CITY OF ALBUQUERQUE

PLANNING DEPARTMENT – Development Review Services

RE: American Toyota (File: C18D012)
Drainage Report, Engineer's Stamp Date 3-16-15
Grading and Drainage Plan, Engineer's Stamp Date 3-17-15

REVISED
DRAINAGE REPORT

ENGINEER'S SEAL	AMERICAN TOYOTA	DRAWN BY: MCH
		DATE: 3-17-15
	GRADING AND DRAINAGE PLAN	PUB-1487-1-03-11
	Rio Grande Engineering	SHEET #
	1000 CENTRAL AVENUE SE SUITE 100 ALBUQUERQUE, NM 87104 (505) 275-0888	JOB #
DAVID SOULE P.E. #14522		21403

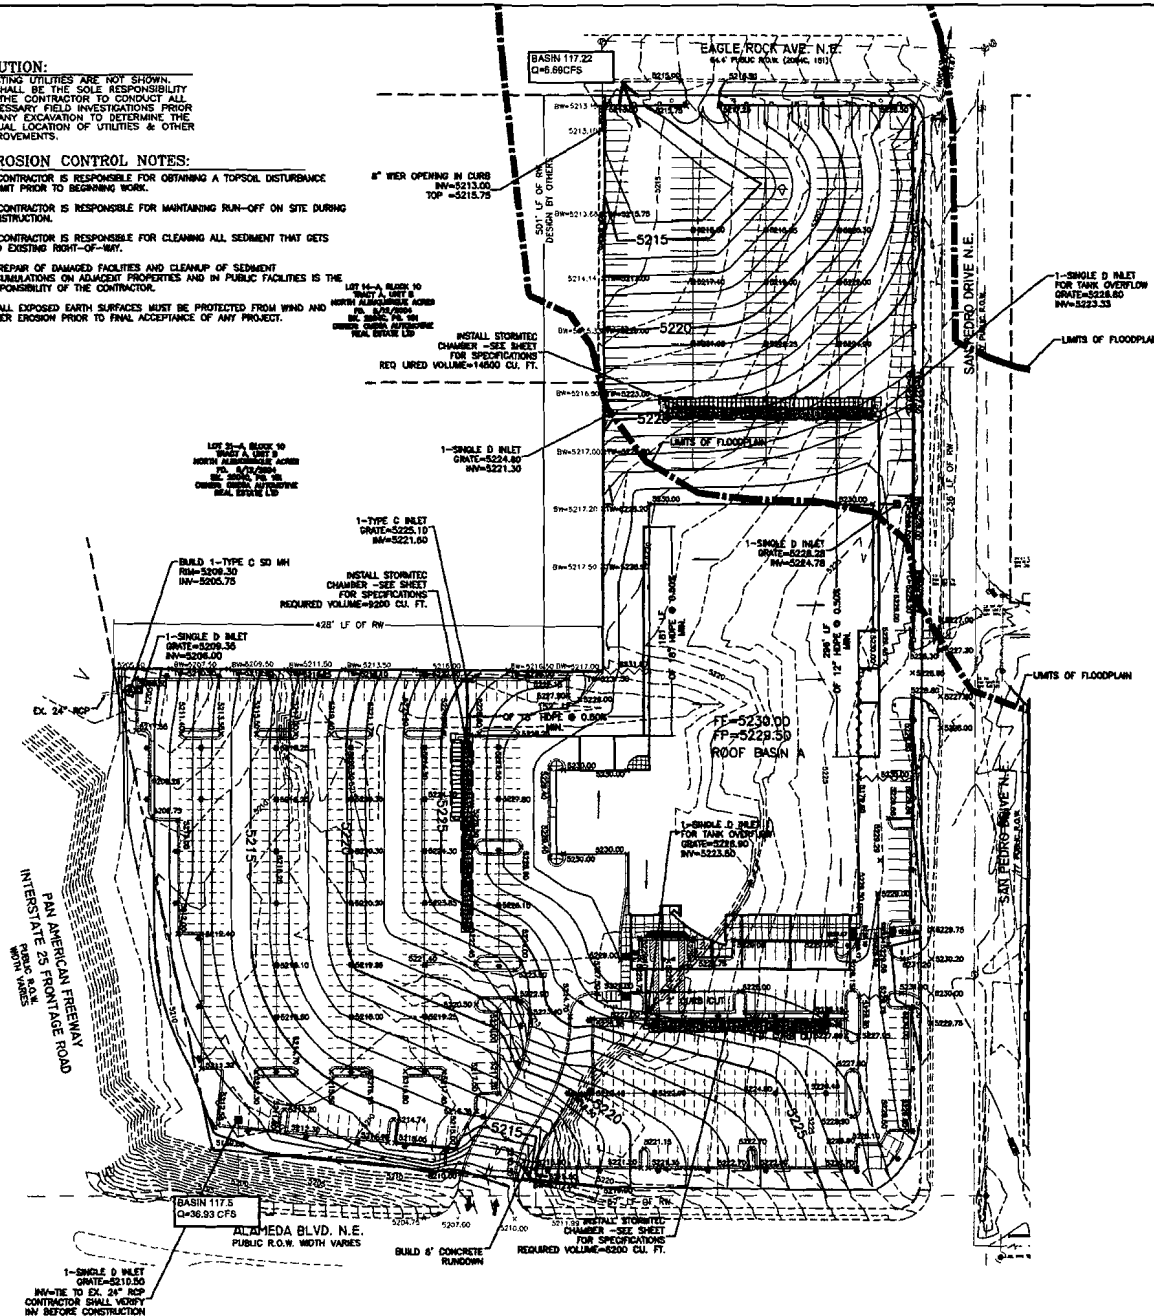
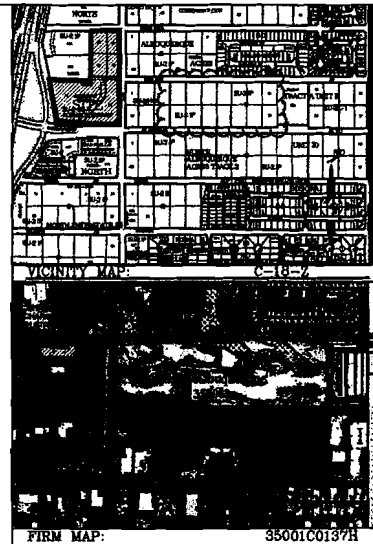
1. The proposed runoff to the Alameda Storm Drain is limited to 25 cfs. This is based on trying to reconcile the difference between the existing runoff of 33 cfs and the allowed runoff of 16 cfs from SAD #201(though this site is not a part of the hydrology report).
2. The "first flush" needs to be captured at Outfalls 2,3, and 4.
3. Details showing how the "first flush" mechanism will work need to be shown prior to approval for Building Permit.
